RE: S.E.E. Associates
164 Auburn Road
Proposed Office Building
John Zepko Project Review Letter Dated 8-25-25

S.E.E. Associates is in receipt of your review letter dated August 25, 2025. You provided this letter following a developer's conference which was suggested by the Planning Board at their July 28, 2025, meeting. The developer's conference was held on August 5, 2025, and attended by you, Dean Shea – Planning Board Chairman, Eric Eisenhut – S.E.E. Associates, and myself. I have included the items from your review letter below as *italicized text* and have provided our responses in **bold text**.

**Sight Distances for Proposed Driveway in Location Shown Above
Measured in Field on 5-9-25 and Graphically Represented Below**

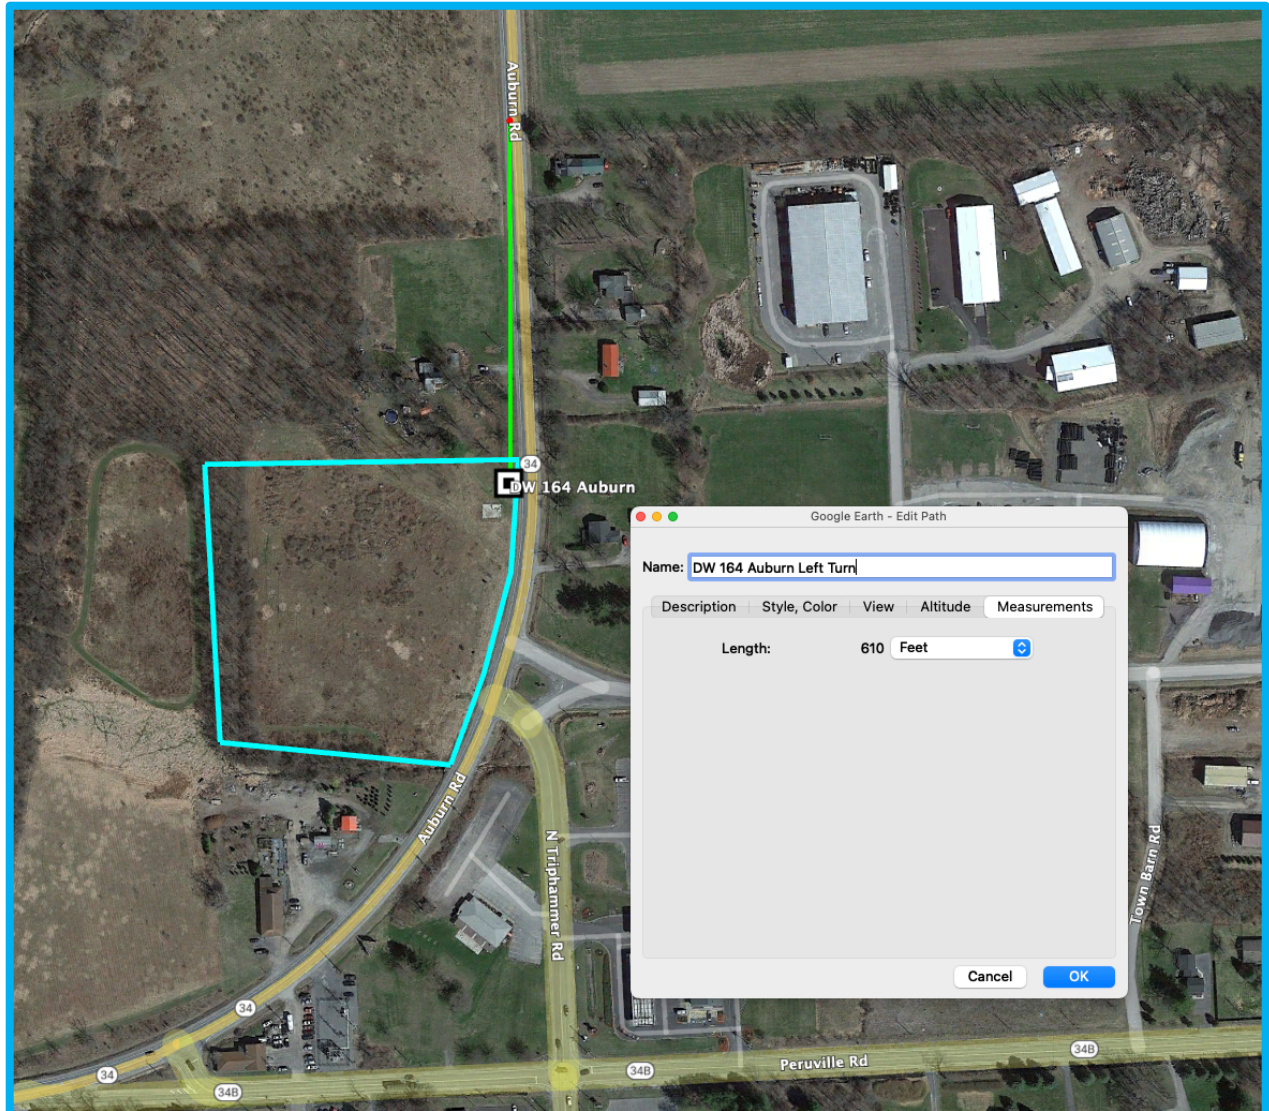
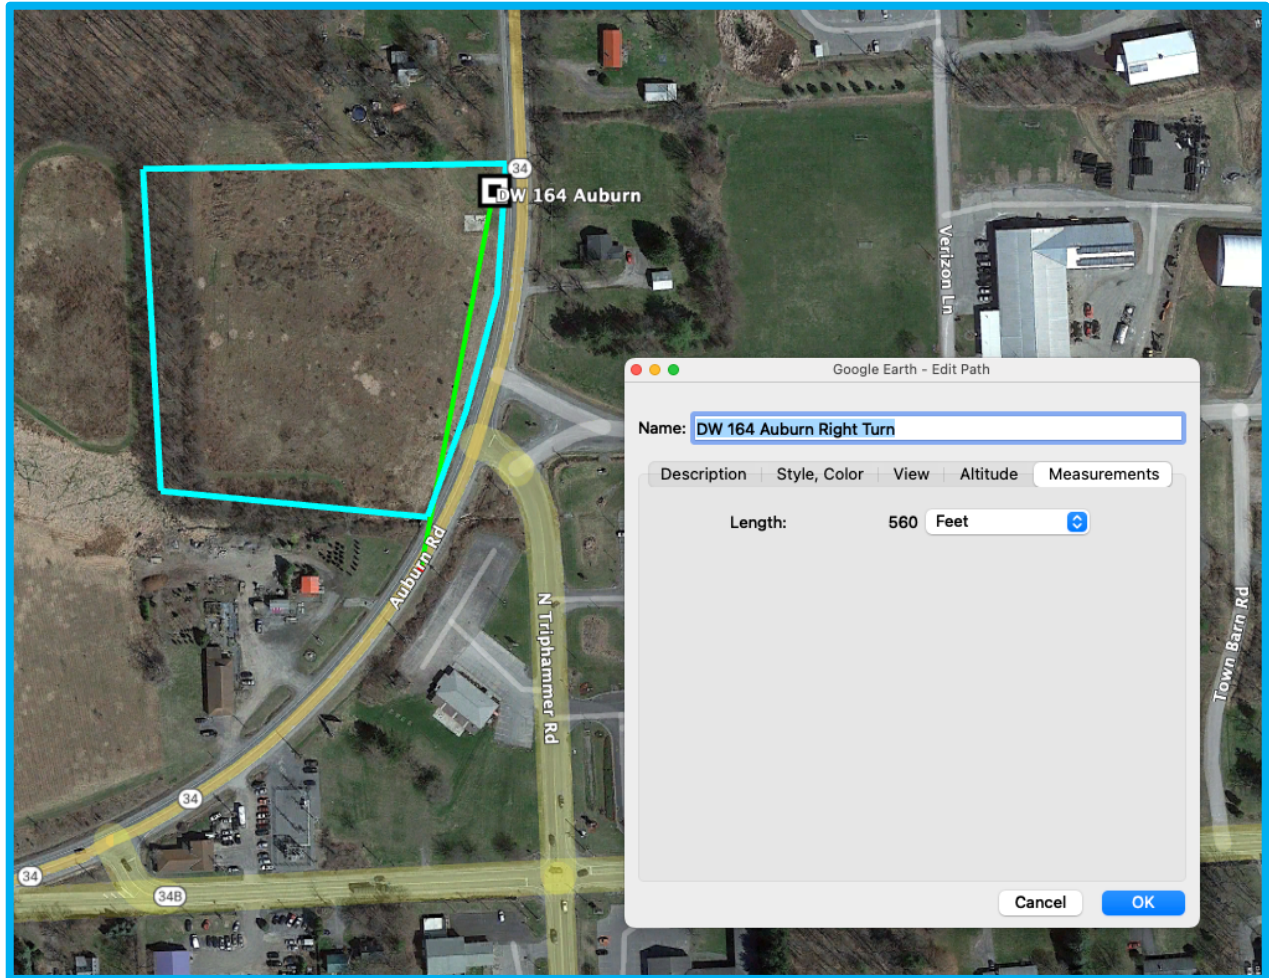
3. *The applicant should provide AM/PM peak hour trips from the latest edition of the ITE Manual.*
S.E.E. Associates submitted a Stage 1 Commercial Driveway application and sight distance calculations to the NYSDOT on September 18, 2025. The Stage 1 application requires an estimation of AM/PM peak hour trips based on similar development history, the ITE manual, or a Professional Engineer's estimate. A Professional Engineer's estimate was provided as part of the application. Based on that estimate, the NYSDOT has approved the driveway location and has not requested a trip generation based on the ITE manual. A copy of the Stage 1 application, sight distance calculations, and NYSDOT email approving the driveway location are attached to this letter.

Measured Sight Distance Looking North (Left Turn) = 610'

Measured Sight Distance Looking South (Right Turn) = 560'

sheet no. HYD

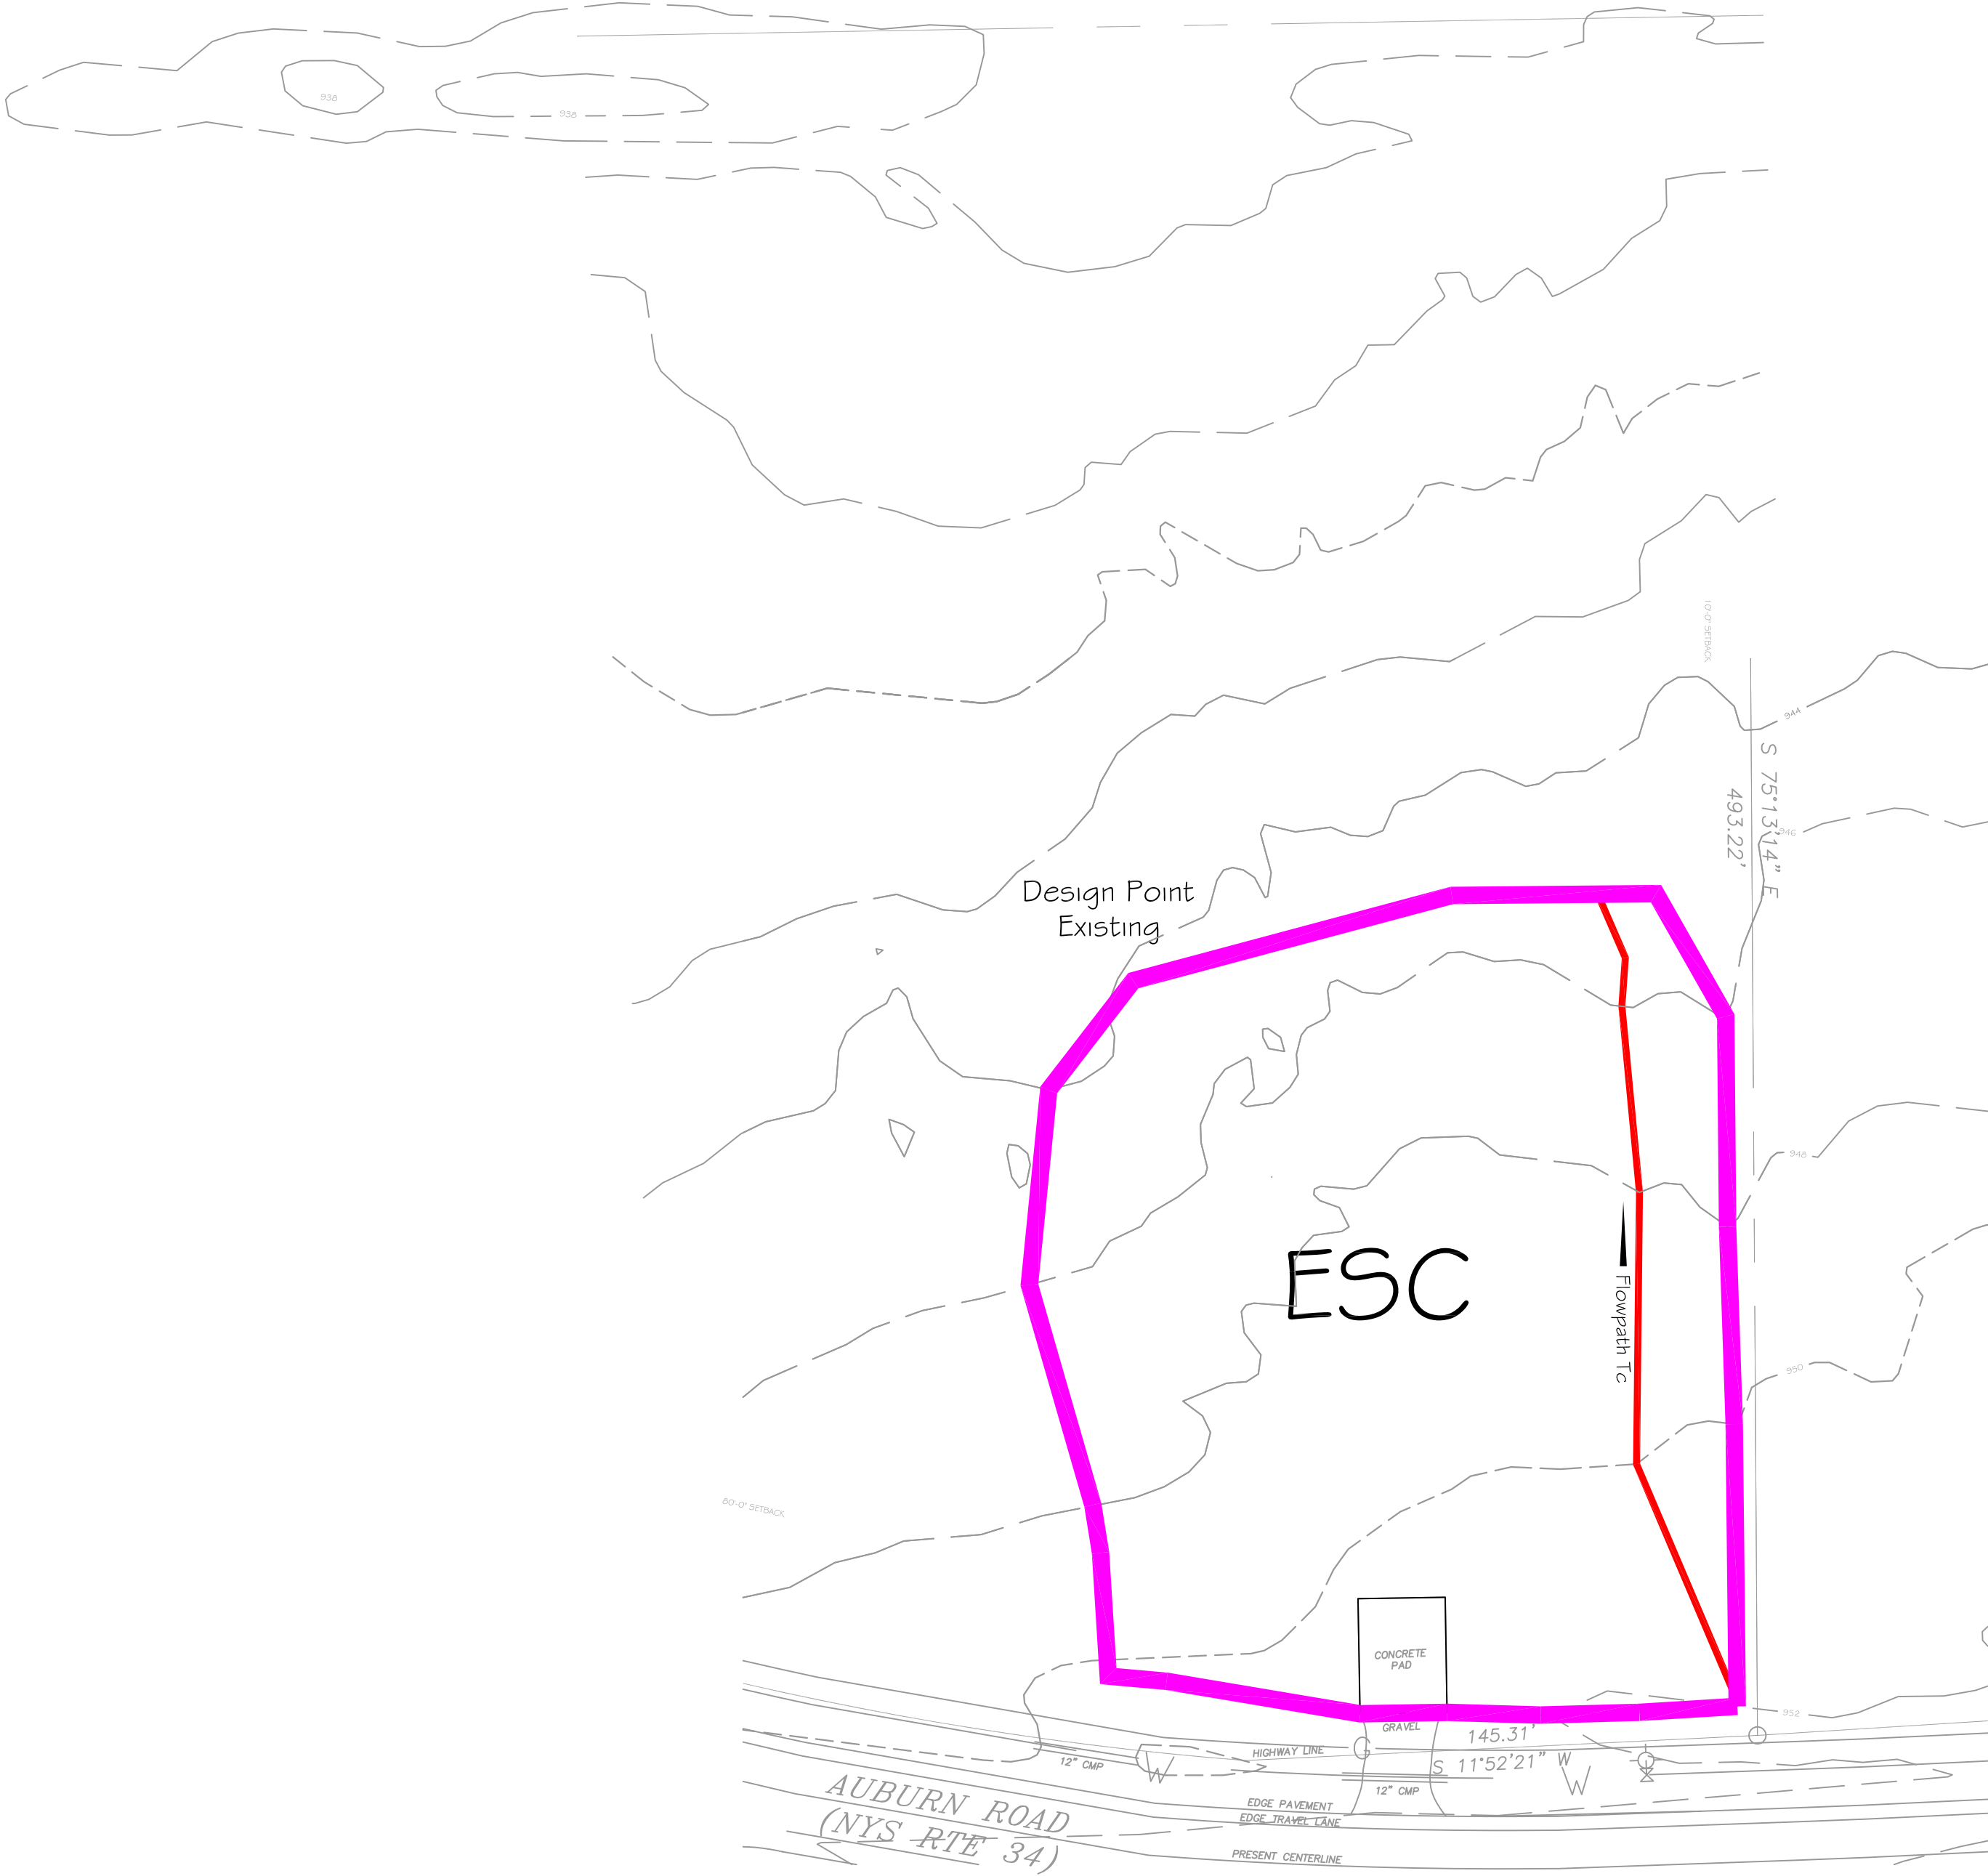
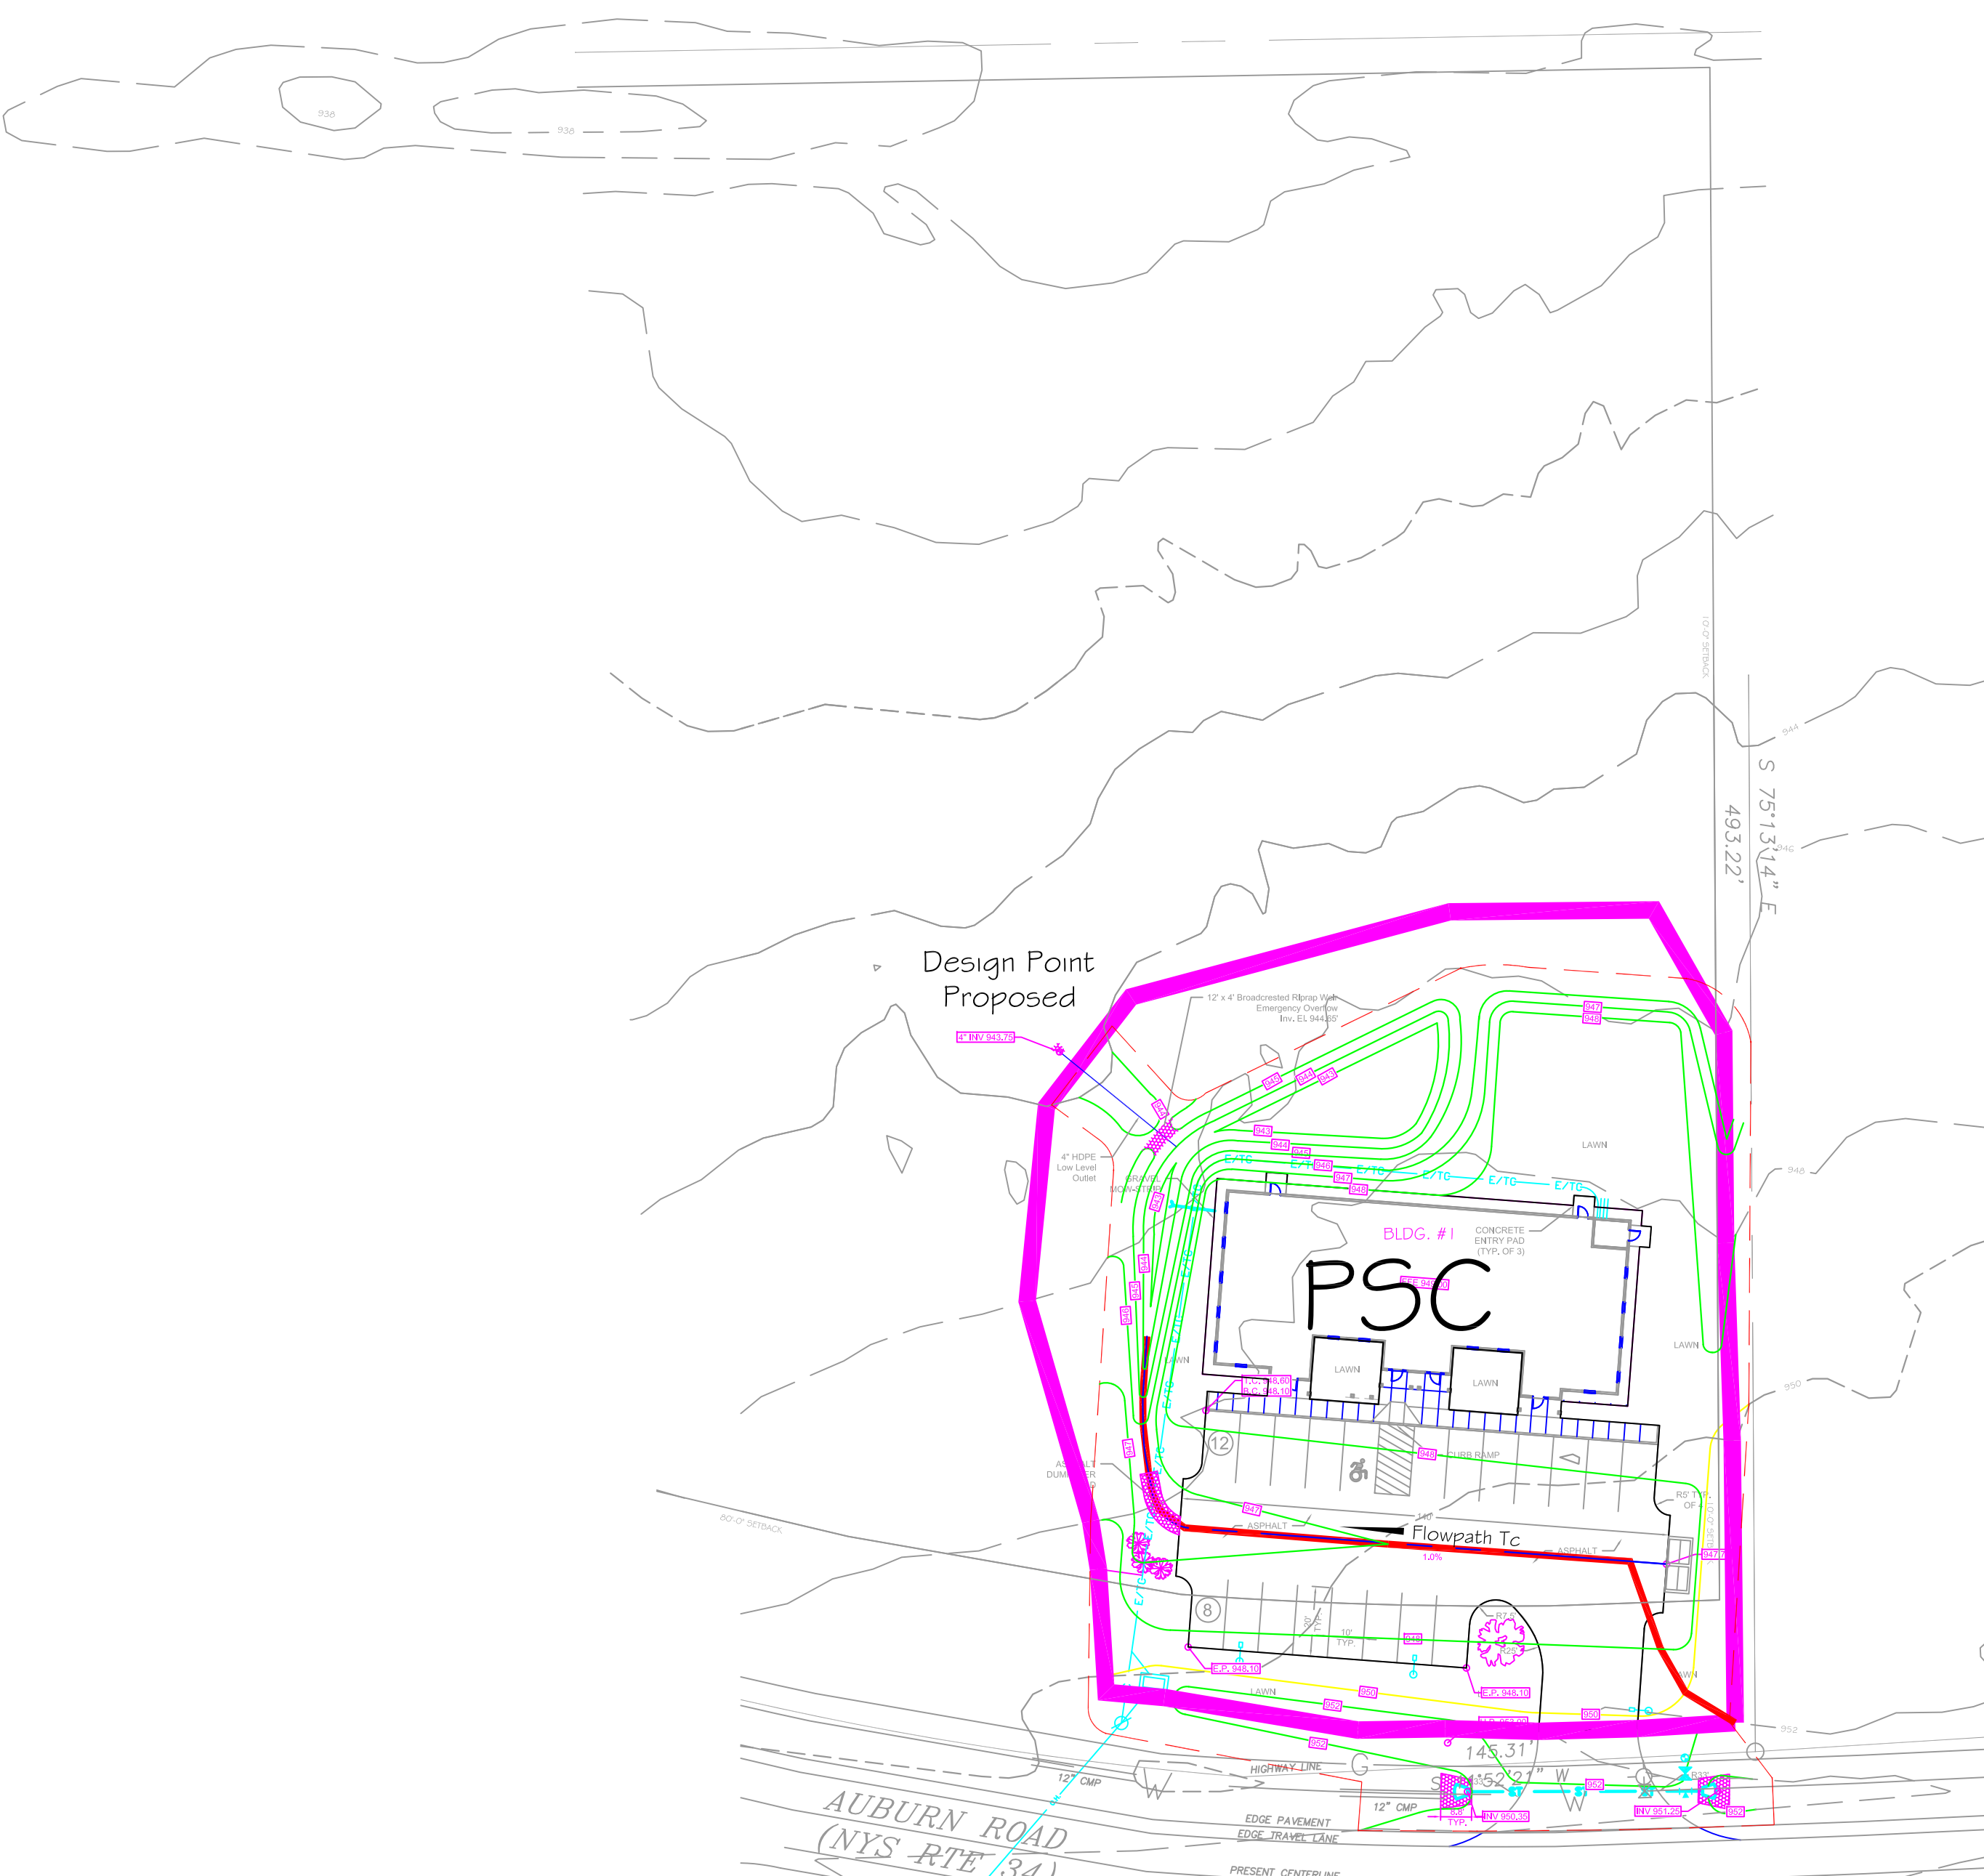
4. Please provide a stormwater management plan that shows the quantity of and method by which stormwater will be attenuated. (§270-27 H. (1) and (2)).
We presented a preliminary grading plan and calculations at the developer's conference for a stormwater attenuation basin to be located along the southern and western limits of the project. This basin will reduce runoff rates from the 1- and 10-year storms to below pre-developed conditions and reduce runoff from the 100-year storm by 8%. The basin has been further detailed on the revised drawing set, and a copy of the updated hydraulic calculations has been attached to this letter.

Runoff Rates and Volumes			
	1 yr	10 yr	100 yr
	1.99"/24 hr	3.40"/24 hr	5.83"/24 hr
Existing	0.190 cfs	1.050 cfs	3.090 cfs
	0.018 af	0.072 af	0.203 af
Proposed	0.000 cfs	0.330cfs	6.290 cfs
	0.000 af	0.046 af	0.213 af
			*Without Attenuation
